Licensing Topical Report

Applicability of GE Methods to Expanded Operating Domains

SUBJECT: FINAL SAFETY EVALUATION FOR GE HITACHI NUCLEAR ENERGY
AMERICAS TOPICAL REPORT NEDC-33173P, REVISION 2 AND
SUPPLEMENT 2, PARTS 1-3, "ANALYSIS OF GAMMA SCAN DATA AND
REMOVAL OF SAFETY LIMIT CRITICAL POWER RATIO (SLMCPR) MARGIN"
(TAC NO. ME1891)

Figure 4-1 Void coefficient vs. instantaneous Void Fraction for a Range of Historical Void Fractions at an Exposure of 30 GWd/MT

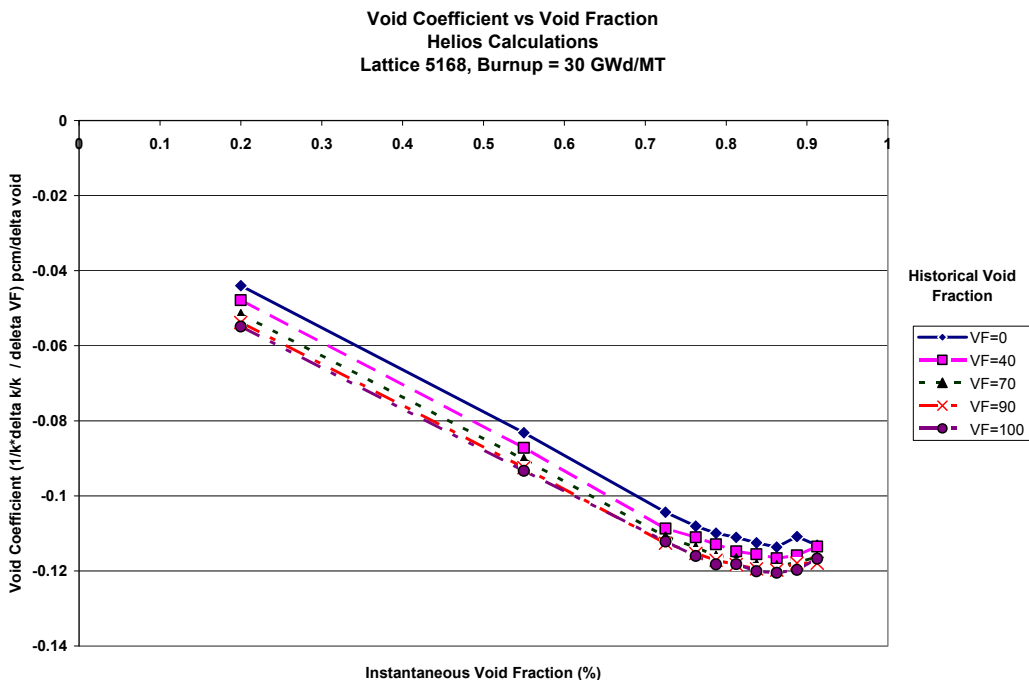
Comparisons of the void reactivity coefficients for the different void history cases and exposures based on ORNL HELIOS calculations are presented in Figure 4-1 and Figure 4-2. Note that additional instantaneous branch points were calculated at the higher void conditions to resolve the non-linearity of the void coefficient with respect to IV fraction at high fuel exposures. The impacts of the different void histories are evident at the higher void fractions with the increasing differences in the void reactivity profiles with increasing exposure. The difference in the profiles [] represents a potential error resulting from GE's methodology. The errors for exposures of about 30 GWd/ST and less are consistent with the [] assumed in the ODYN analysis. However, for higher exposures at high void fractions the error increases []. In addition, the deviation of the void reactivity from a linear variation represents an error that results from the quadratic extrapolation used in GE's methodology. As shown in these figures, at high void fractions and high exposures the profile deviates from linear.

Figure 5-1 Impact of Bypass Voiding on Peak Pin Fission Rate

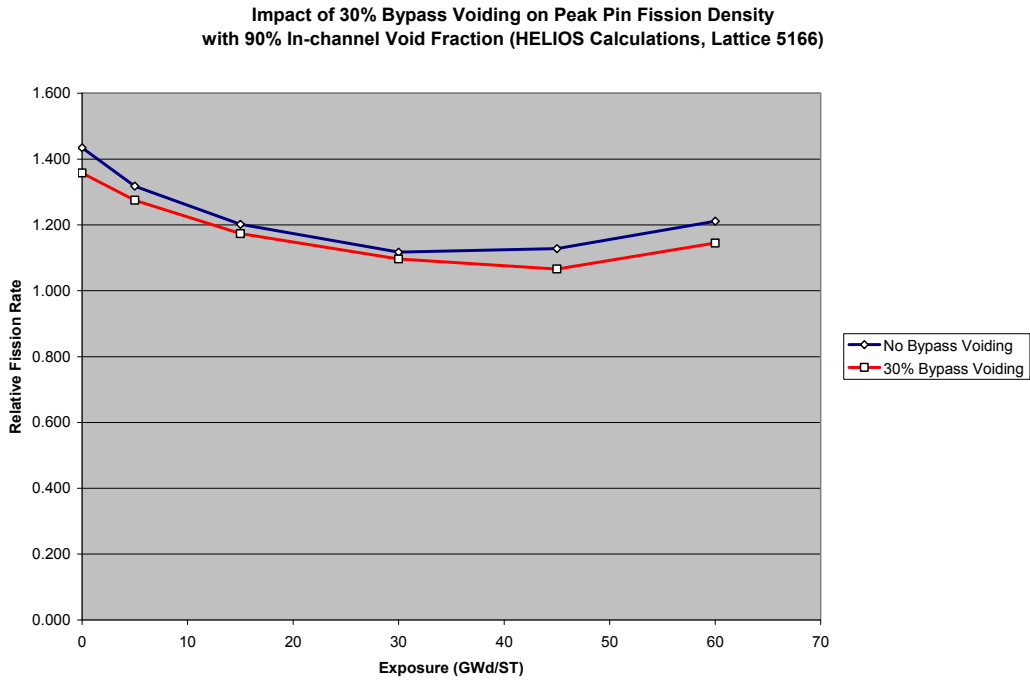
Figure 5-1 provides a comparison of the peak relative pin-fission rate for 90 percent in-channel void fraction with and without a 30 percent bypass void fraction. Figure 5-2 provides a similar comparison, but based on an RMS of the difference of the relative pin-fission rates from unity. This later parameter provides an indication of the overall "flatness" of the lattice pin power distribution. The results indicate, as discussed above, that the peak pin-fission rate is reduced and the lattice pin-fission rate distribution is more uniform (flatter) for the case with bypass voiding. Therefore, as far as lattice peaking is concerned, bypass voiding does not have a negative impact. In addition, the 30 percent bypass voiding considered greatly exceeds the maximum value of 5 percent indicated by GE for steady-state operation.

Figure 7-6 Void Fraction-Quality Relation with Partial Length Rods at Low Flow

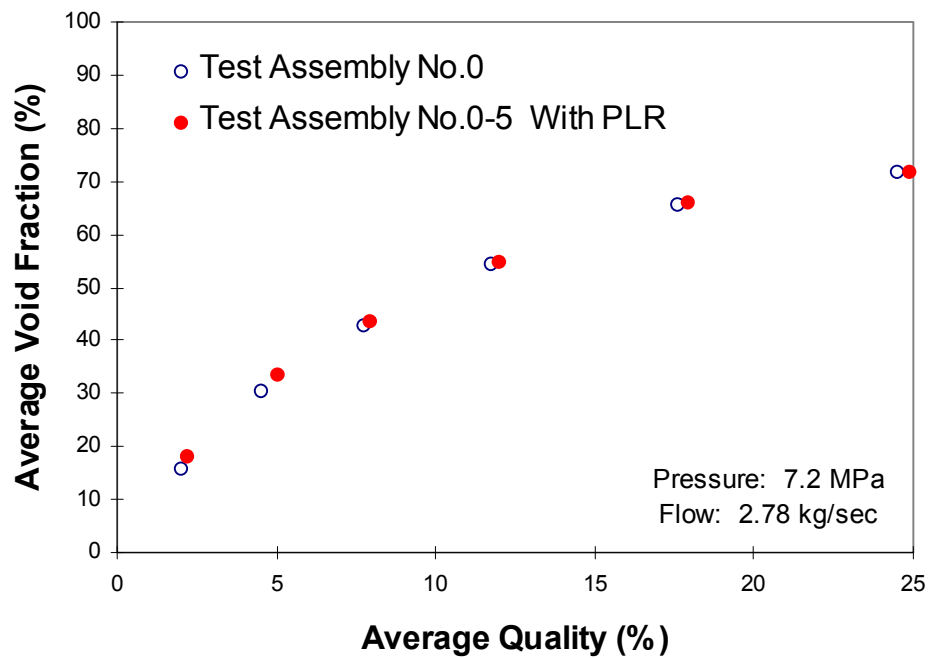
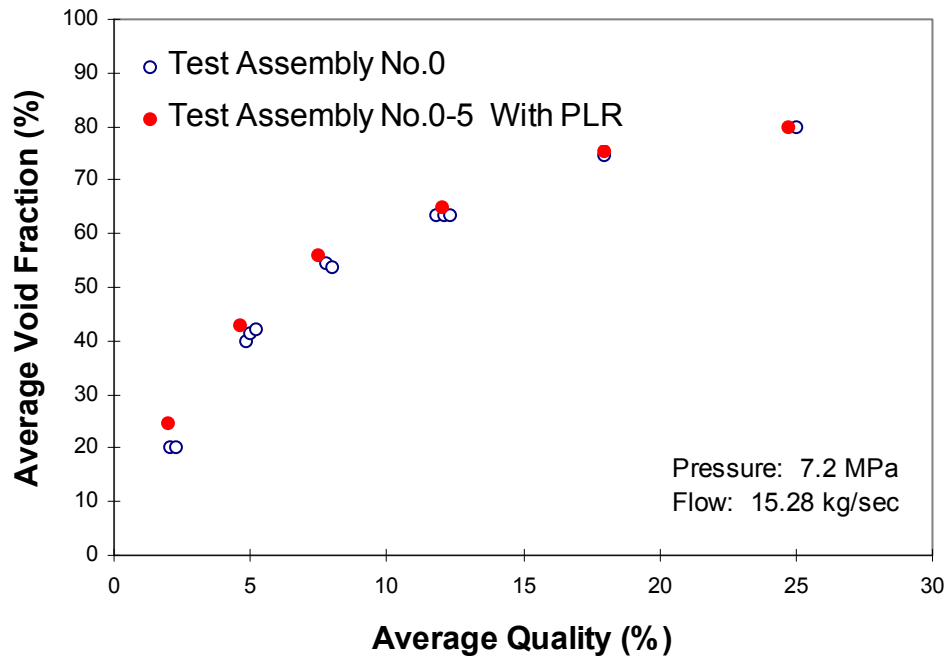
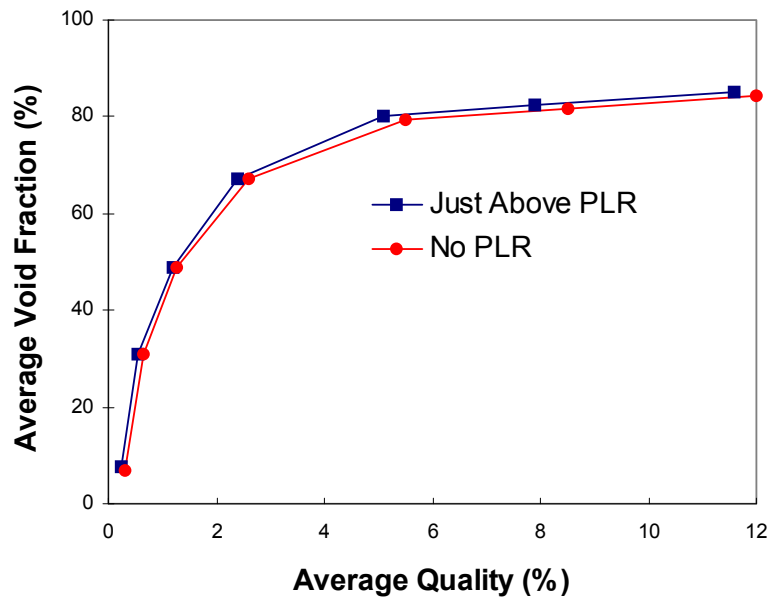
GE presented three plots showing the effect of partial length rods on void fraction (Response to RAI 5.2, Reference 9), which are shown as Figure 7-6 through Figure 7-8. The data in these plots were Japanese data taken from the open literature. The data indicates only a minor change in void fraction between bundles with and without partial length rods. GE noted that the void fraction correlation was not compared to this data because sufficient information about the test apparatus was not available. This limits the usefulness of data since there is no quantitative comparison with Findlay-Dix void that would allow the performance of the Findlay-Dix void-quality correlation to be evaluated for partial length rods.

Figure 2.2-1 Sensitivity of Cold Critical Eigenvalue to EPU Operation

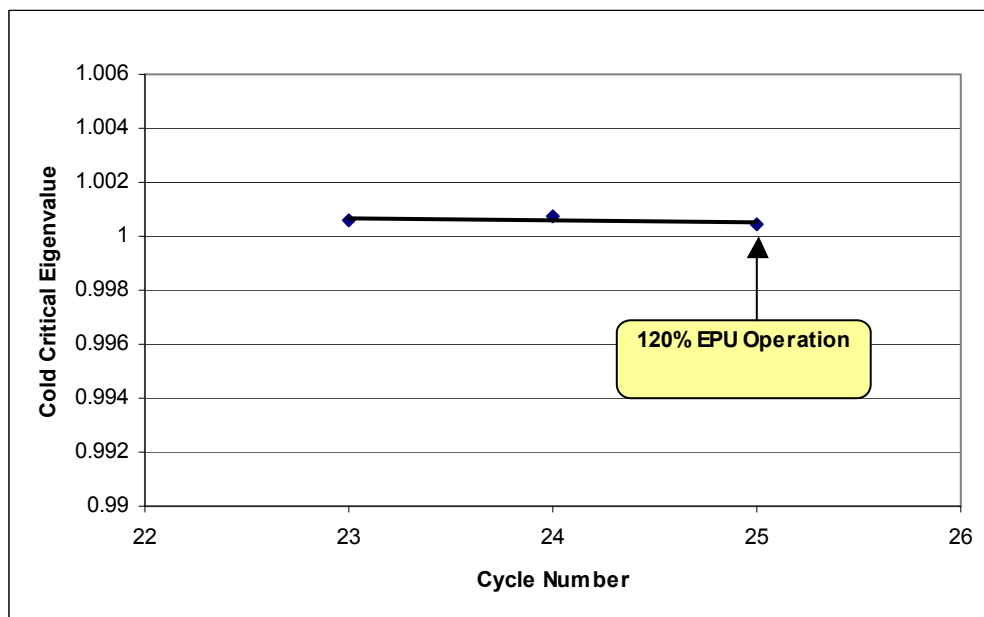
The impact of EPU operation was assessed by the review of data provided in request to RAI 2.2 of MFN06-195 (Reference 10), which provides data for three successive cycles (23, 24, and 25) for a plant that began EPU operation in Cycle 25 (see Figure 3-15). However, both Cycles 24 and 25 were designed for EPU operation. The data provided indicates that there is essentially no change in the cold critical prediction based on EPU core designs.

Figure 5-1 – TIP Locations for FitzPatrick

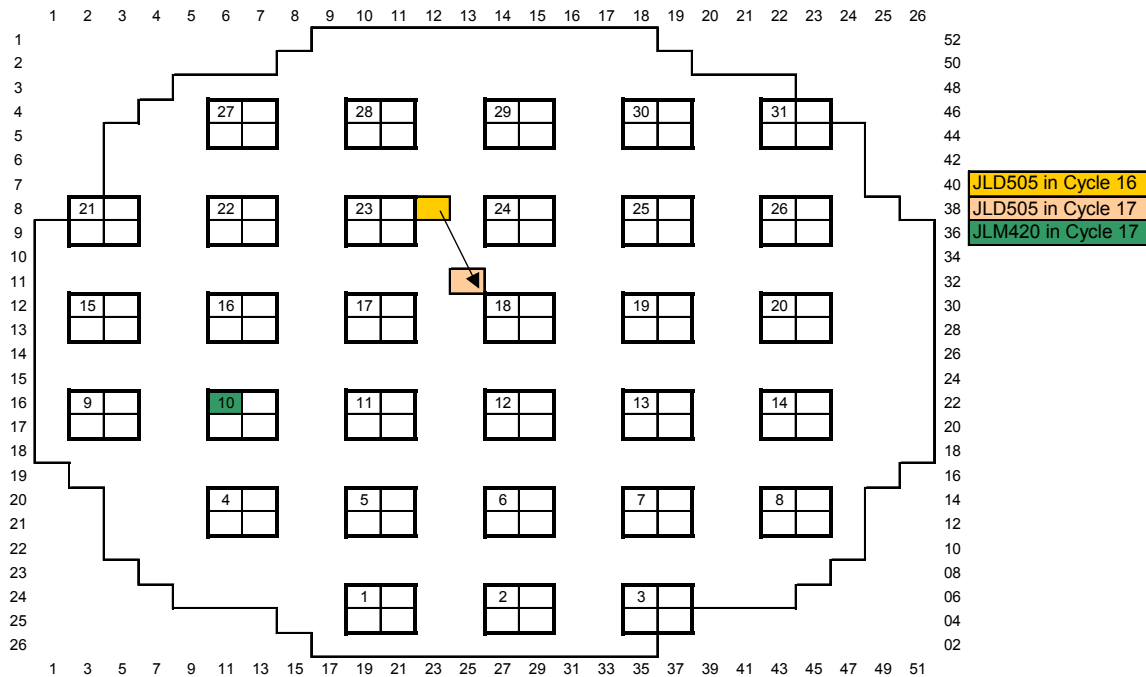
The figures provided in Section 8 appear to indicate a []. This appears to the NRC staff to be a []. The NRC staff requested additional information regarding this corner rod in several RAIs. In reference to Figures 2.3-1 and 2.4-1 of Supplement 2, Part 2, GEH was asked to indicate where the nearest instrument tube is located relative to the scanned bundles. GEH responded by providing Figure 5-1 (Reference 14), showing the locations of the TIP strings in JAF, with each TIP instrument tube identified by the TIP string number. The TIP string is located at the bottom, right-hand corner of the bundle with the TIP string number. GEH pointed out that the four-bundle cells highlighted in Figure 5-1 are the four-bundle cells surrounding the TIP string. However, GEH did not identify the four bundles around a control rod. GEH also pointed out that JLD505 is not adjacent to an instrument tube in either c16 or c17, while JLM420 is adjacent to an instrument tube.

Figure 5-1 provides the locations of the TIP strings in FitzPatrick, with each TIP instrument tube identified by the TIP string number. The TIP string is located at the bottom, right hand corner of the bundle with the TIP string number. Note that the four bundle cells highlighted are the four bundle cells surrounding the TIP string, and do not identify the four bundles around a control rod. Note that JLD505 is not adjacent to an instrument tube in either Cycle 16 or 17, while JLM420 is adjacent to an instrument tube in Cycle 17.
